M3 Junction 9 Improvement	July 27th 2023D4-Errata version-Aug 18th 2023
Planning Examination 2023	Written Representation (WR)

Author Details	
Name	Dr Andrew Boswell
Position	Scientist and Consultant
M3 Junction 9 Registration	20036820
Organisation	Climate Emergency Policy and Planning (CEPP)
Examination Principle Issues	Climate Change

WRITTEN REPRESENTATION

Figure 2: CCC Progress Report 2023, Fig 3.13 reproduced

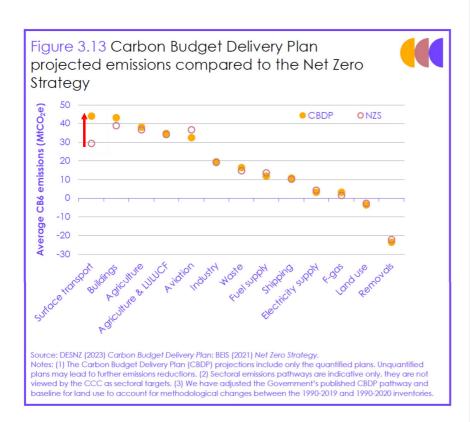
- 36 Figure 3.13, reproduced over the page, compares the residual emissions (the emissions which are calculated to be left remaining after decarbonisation policies and proposals) for each sector for an average year in the 6CB (ie: the mid-year 2035). The red arrow shows that the residual emissions for surface transport were 29.4 MtCO2e in the NZS (published 2021) has now been recomputed as 44.2 MtCO2e in the CBDP (ie 50% higher).

- 37 Only the surface transport sector in the CBDP has a serious shortfall compared to the NZS. The shortfall is 14.8 MtCO2e/yr in the 6CB as highlighted on the figure below, and clearly shows surface transport as being by far the largest adjustment.

- 38 In terms of the simple diagram presented at Figure 1 above, and the extremely tight and inflexible emissions space, what is happening is that the surface transport sector already, at its existing levels, cannot fit into the EmSp for Net Zero. The result is that the country is projected not to meet its legislated near-term (2030 and 2035) carbon targets on the basis of the CBDP analysis. Whilst, the Government do say in the CBDP that they intend to make up the shortfall²⁵, it is not clear whether the gap will be, or can be, fully closed, nor how the proposals for closing the gap will be risk assessed (as they don't exist yet).

Figure 3:CCC Progress Report 2023, Fig 4b reproduced

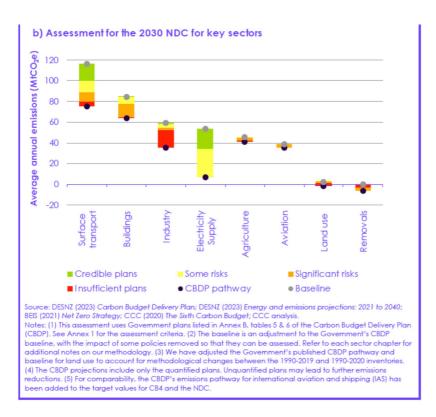
- 43 Figure 4b on page 24 of CCC_2023_PROG, reproduced below, shows that the surface transport and industry sectors have the largest emission reductions²⁷ for the 2030 NDC.
- 44 Surface Transport is required to reduce from a baseline of 116.7 MtCO2e/yr to 75.3 MtCO2e/yr (the "CBDP pathway") in 2030. The CCC assess credible plans only existing for 40% of this (16.6 MtCO2e/yr green on the Figure).
- 45 Industry is required to reduce from a baseline of 59.3 MtCO2e/yr to 35.4 MtCO2e/yr (the "CBDP pathway") in 2030. The CCC assess credible plans only existing for 4.6% of this (1.1 MtCO2e/yr green on the Figure). The Industry sector is important in assessing the significance of the construction emissions from the M3J9 which fall in the Industry sector. The M3J9 construction emissions are 37,070 tCO2e 1.762 MtCO2e [ES Chapter 15, Table 15.14] and fall in the period up to the 2030 NDC.

Figure 4: CCC Progress Report 2023, Fig 4.10 reproduced

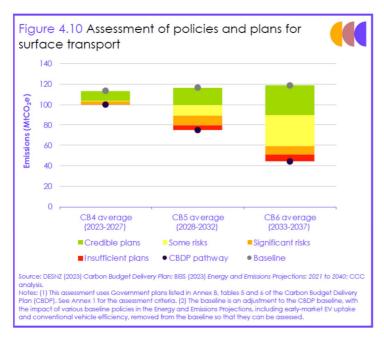
- 46 Figure 4.10 on page 122 of CCC_2023_PROG, reproduced below, shows the assessment of policies and plans for surface transport across the 4^{th} , 5^{th} and 6^{th} carbon budgets.
- 47 For the 6CB, surface transport is required to reduce²⁸ from a baseline of 118.8 MtCO2e to 44.2 MtCO2e. The CCC assess credible plans only existing for 38.8% of this (28.7 MtCO2e/yr green on the Figure). A remaining 45.73 MtCO2e of surface transport emissions reductions require to be fully secured in the 6CB.

48 For the 5CB, surface transport is required to reduce²⁹ from a baseline of 116.8 MtCO2e to 75.3 MtCO2e. The CCC assess credible plans only existing for 39.9% of this (16.6 MtCO2e/yr – green on the Figure). A remaining 24.52 MtCO2e of surface transport emissions reductions require to be fully secured in the 5CB.

49 The report finds that overall "credible plans" exist for <u>less than 39%</u> of the required emissions reduction in surface transport to meet the Sixth Carbon Budget. This means that **61% of the required emissions reductions in surface transport for the 6th carbon budget are not fully <u>secured</u> "on paper" yet. This reveals the true extent of the "delivery gap" in transport decarbonisation policy from the Government's own advisors on climate change delivery.**

Figure 5: CCC Progress Report 2023, Fig 6.5 reproduced

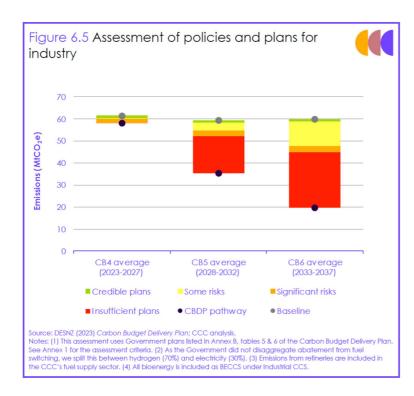
- 51 The construction of the M3J9 scheme comes under the Industry sector.
- 52 Figure 6.5, reproduced below, on page 189 of CCC_2023_PROG, reproduced below, shows the assessment of policies and plans for Industry across the 4th, 5th and 6th carbon budgets.

53 It should be noted that the Applicant has proposed using hydrogen (to replace diesel) in some of the construction operation. The applicant has not provided any assessment of Direct and Indirect effects related to the use of hydrogen and this will affect the validity of any savings claimed by the fuel switch. This is discussed in a later section.

Figure 6: Green Alliance Net Zero policy tracker, sectorial overview

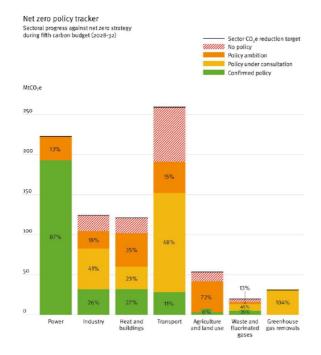
$59\,\mbox{The}$ figure above is for the 5-year carbon budget, 2028-2032, and GA note:

- 60 The policy gaps for surface transport where GA find no targeted government policy (26%) is 13.6 MtCO2e/yr.
- 61 The figure shows that for the industry sector around 20MtCO2e (4 MtCO2e/yr) of no targeted government policy corresponding to a policy gap of 15% for that sector.

Figure 7: Electric vehicle uptake assumptions between original NZS and revised NZS (CBDP) for cars

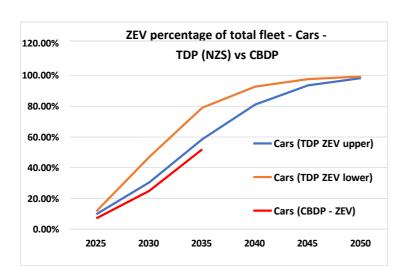
- 76 The graph shows that new baseline trails around 7% below the previous worst case at 2035 (and 27% below the previous best case). Further, it is difficult to see it on the graph, but the CBDP percentage (red) is going up slower than the TDP worst case (blue), as evidenced by the difference/shortfall between the red and blue lines being for 2025: 2.71%, for 2030:5.45%, and for 2035:6.58%. This shows that the projected EV adoption is slower in the new baseline.
